Technical Note

Project	Winchester School of Art	Project No	14398
Subject	HCC Highways Post-Submission Comments	Date	21 August 2026
File Ref	14398-CRH-XX-XX-RP-H-6005_P3_HCCHighwaysTN.docx	Pages	33

1.1 Introduction

Proposed Site Access
Pedestrian Visibility Splays &
Junction Intervisibility Splays
B3330 North Walls

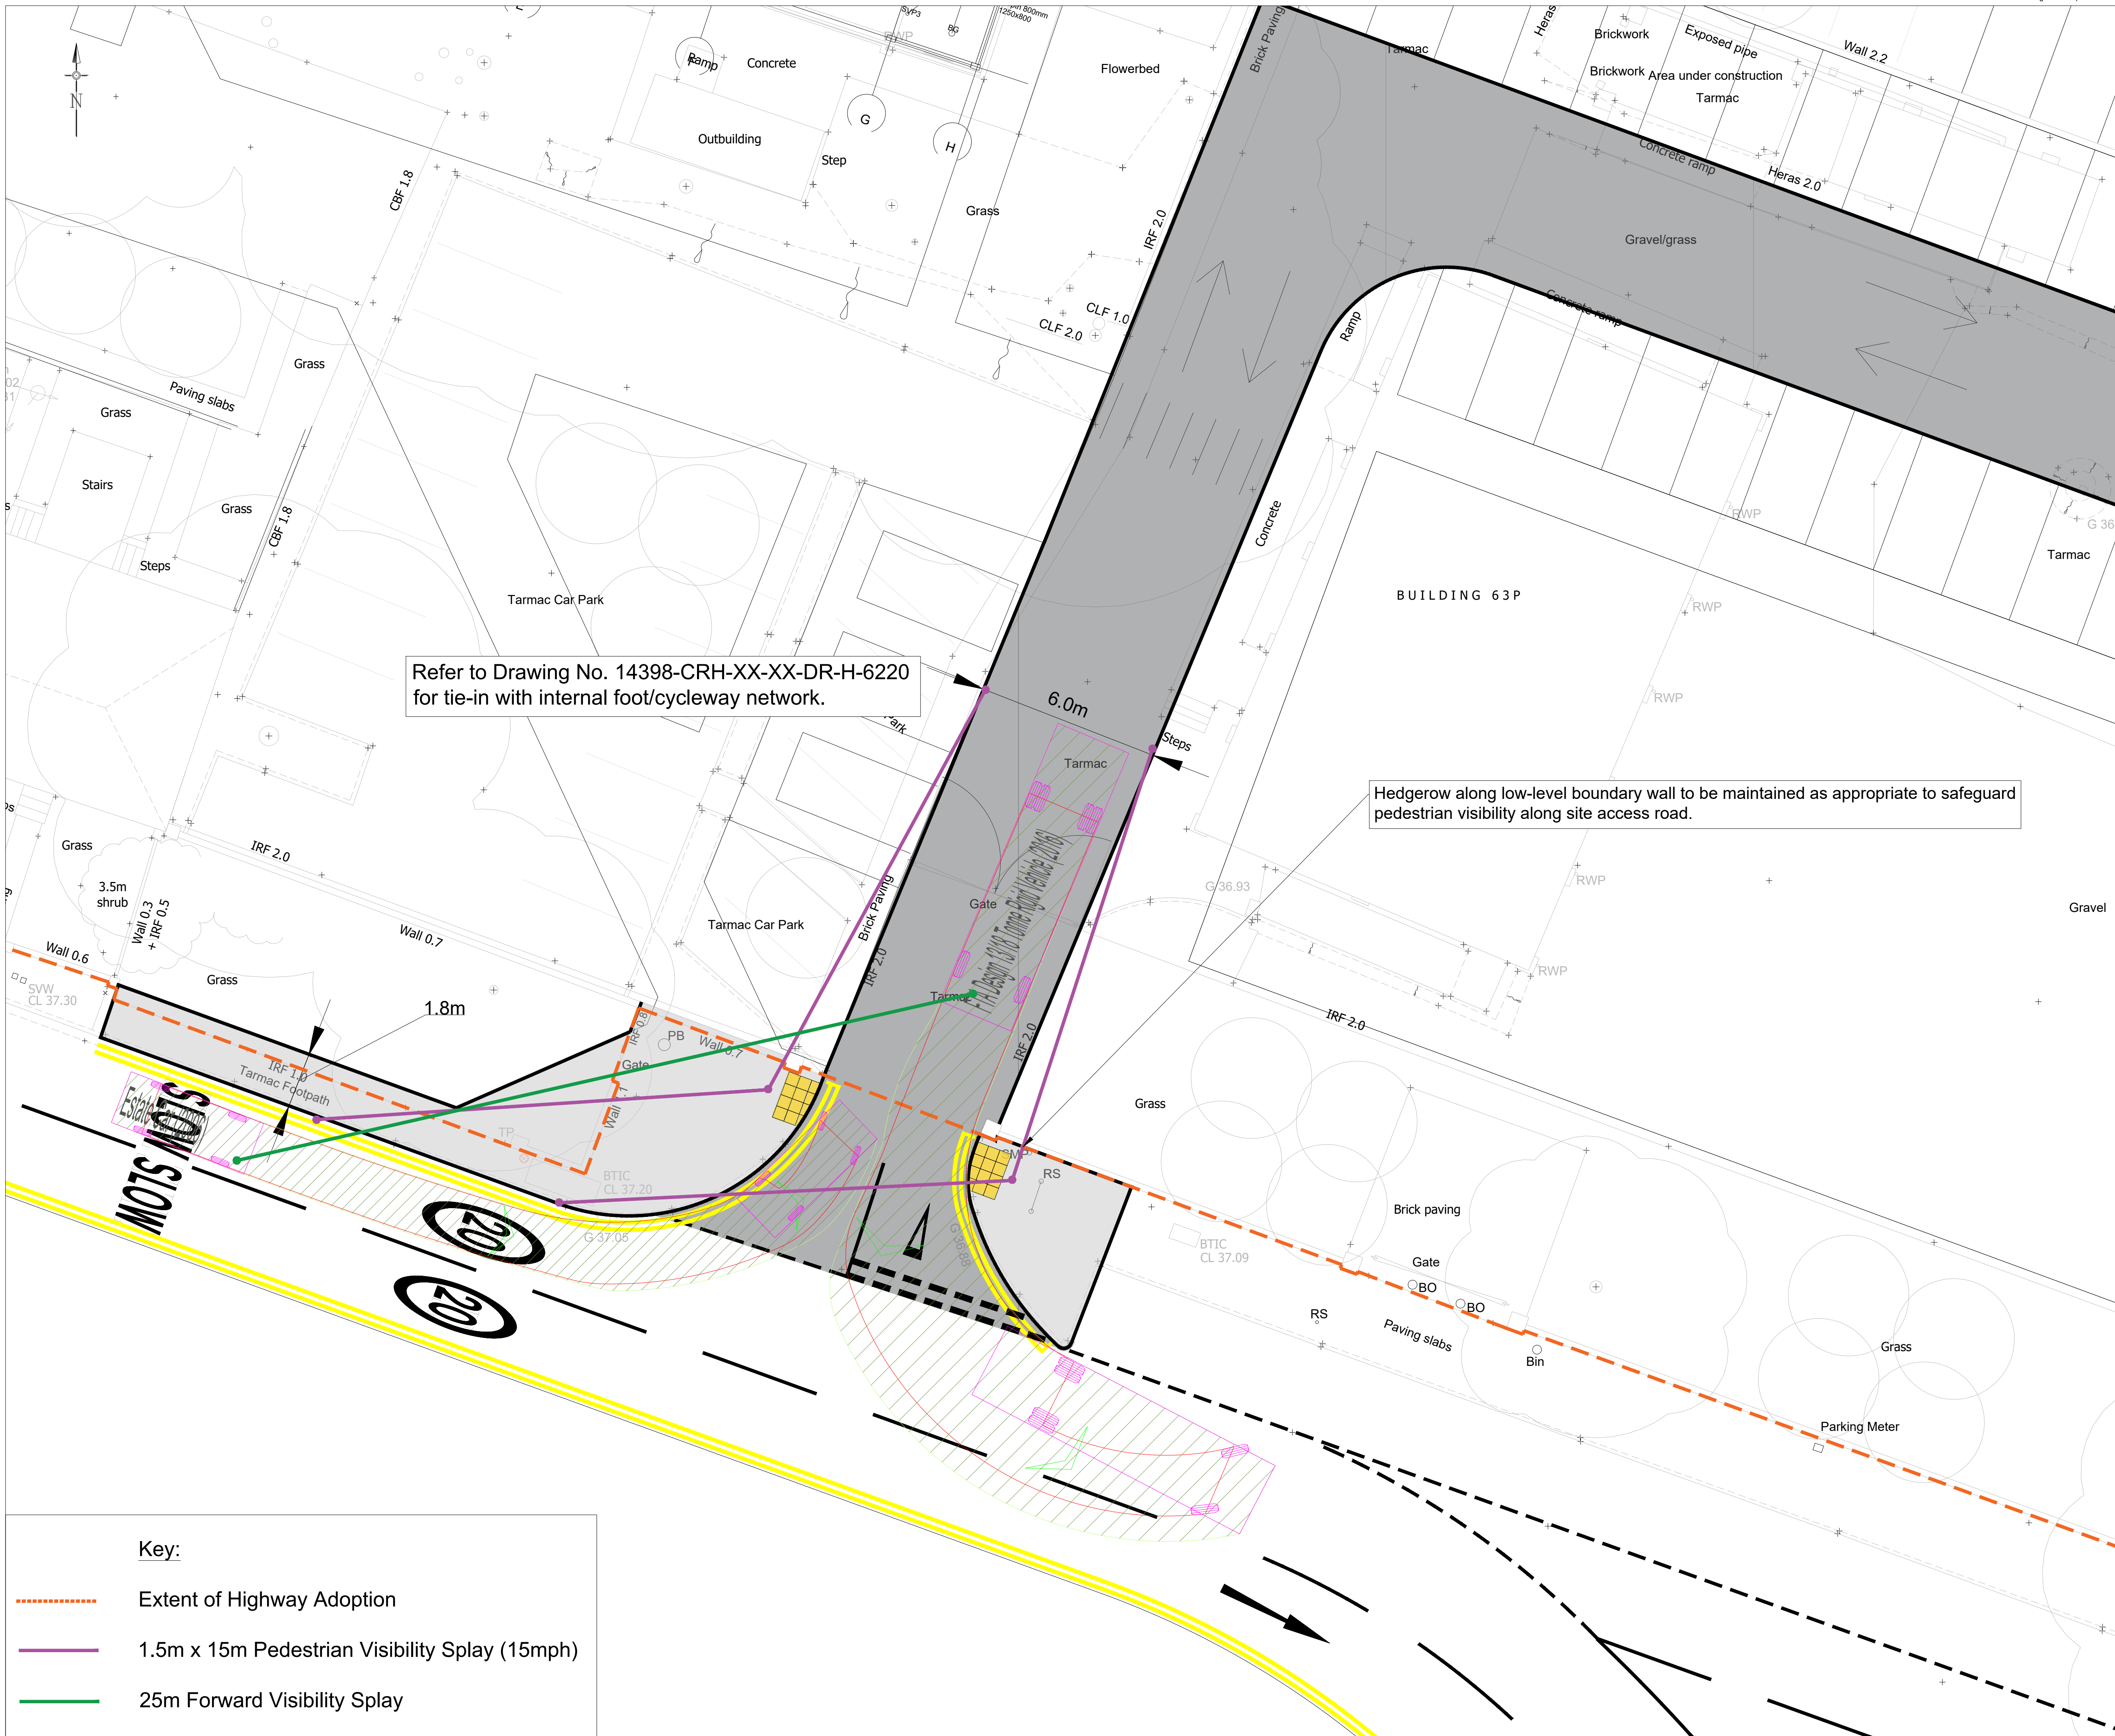
- Concerns regarding pedestrian visibility and intervisibility when looking north into the site to/from North Walls are acknowledged. Refer to Drawing No. 14398-CRH-XX-XX-DR-6202-P1 within **Appendix 2** which shows how pedestrian visibility splays of 1.5m x 15m can be achieved in all directions from the proposed tactile paving, as well as how 25m forward visibility can be achieved between the drivers eyesight lines of an Estate car along North Walls, and a 10.0m Rigid Truck travelling towards the junction within the site boundary. The drawing also shows how an Estate car can wait within the junction bellmouth while the 10.0m Rigid Truck egresses from the site access and onto North Walls.

- HCC requested that pedestrian visibility splays are shown at the proposed site access, from the tactile paving with a 1.5m x-distance (set-back). Refer to Drawing No. 14398-CRH-XX-XX-DR-6202-P1 within **Appendix 2** which shows how pedestrian visibility splays of 1.5m x 15m can be achieved in all directions from the proposed tactile paving. It should be noted that the proposed crossing points across the site access is an existing, dropped kerb arrangement, which is being enhanced as a result of the proposed development via the provision of tactile paving. On this basis, no further consideration is necessary.

Hedgerow along low-level boundary wall to be maintained as appropriate to safeguard pedestrian visibility along site access road.

Proposed Site Access Design B3330 North Walls

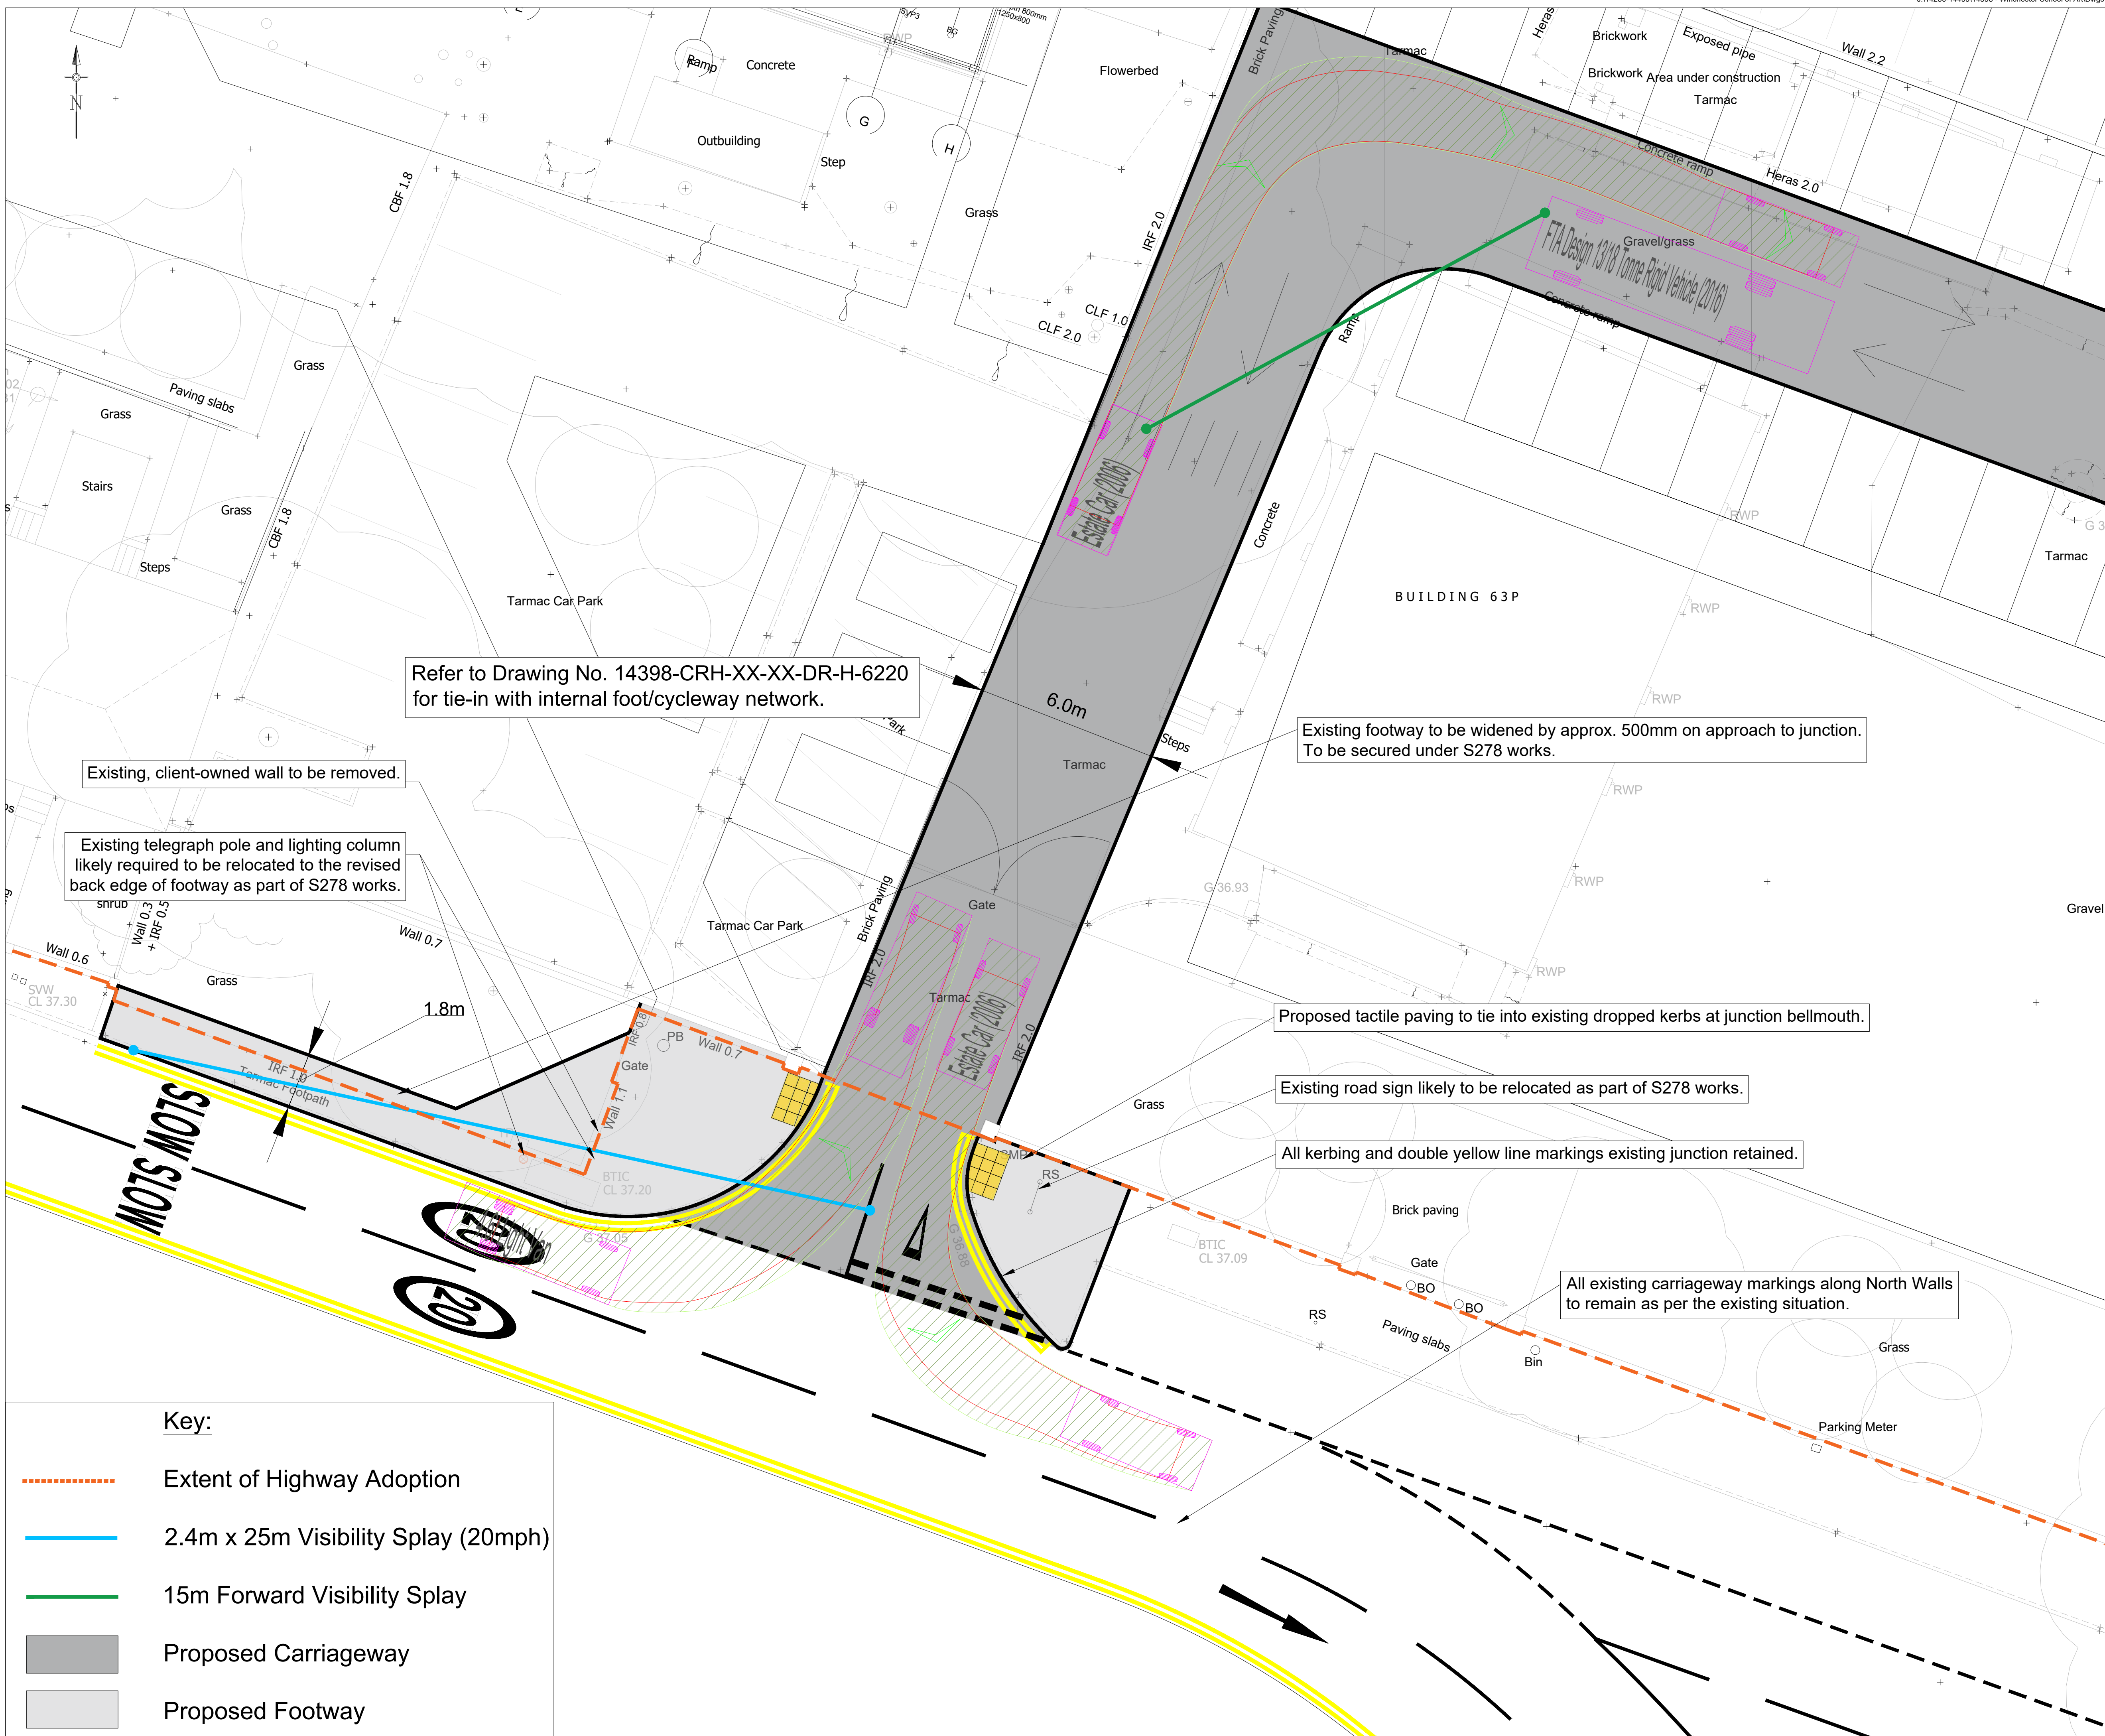
- HCC stated that a car and 4.6t light van passing at the junction are to be shown. Refer to Drawing No. 14398-CRH-XX-XX-DR-6201-P2 within **Appendix 2**, which has been updated to show a 4.6t van passing a car at the junction with no conflict.
- HCC also requested that intervisibility splays are provided around the site access and frontage with North Walls where cars may need to wait for larger vehicles when turning in (and vice versa). This has been addressed within Drawing No. 14398-CRH-XX-XX-DR-6202-P1 within **Appendix 2**.

Existing footway to be widened by approx. 500mm on approach to junction.
To be secured under S278 works.

Proposed tactile paving to tie into existing dropped kerbs at junction bellmouth.

P2	Updated as per HCC comments	04/08/26	TH
P1	Issued for information	23/10/25	TH
Rev	Description	Date	By

Proposed Active Travel Mitigation

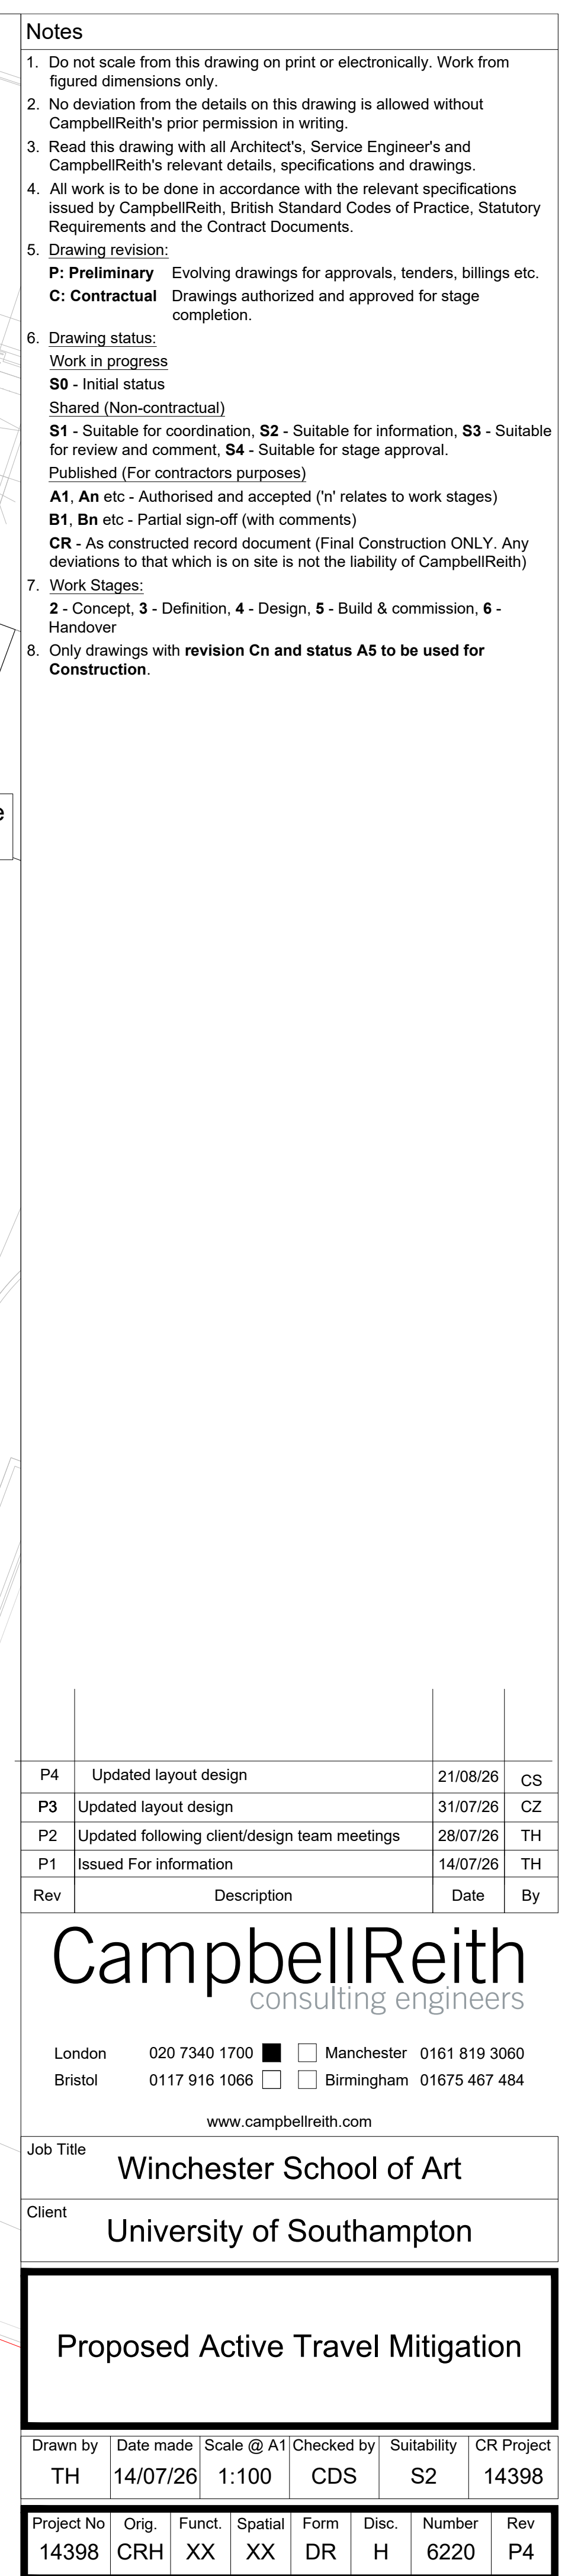
1.2.17 Refer to Drawing No. 14398-CRH-XX-XX-DR-H-6220-P3 within **Appendix 3**.

1.2.20 It should be noted on Drawing No. 14398-CRH-XX-XX-DR-H-6220-P3 within **Appendix 3** that the proposed 3.0m wide footpath connection, between the site access and the southern edge of the shared foot/cycleway facility, has been provided with the appropriate width (3.0m) and lateral clearances (0.5m on both sides) to enable this extent to be converted into an extension of the shared foot/cycleway, for use by cyclists, should future demand dictate. However, as part of these revised proposals, this footpath will be in use for pedestrians only at this stage – with regulatory signage being implemented to prevent its use by cyclists.
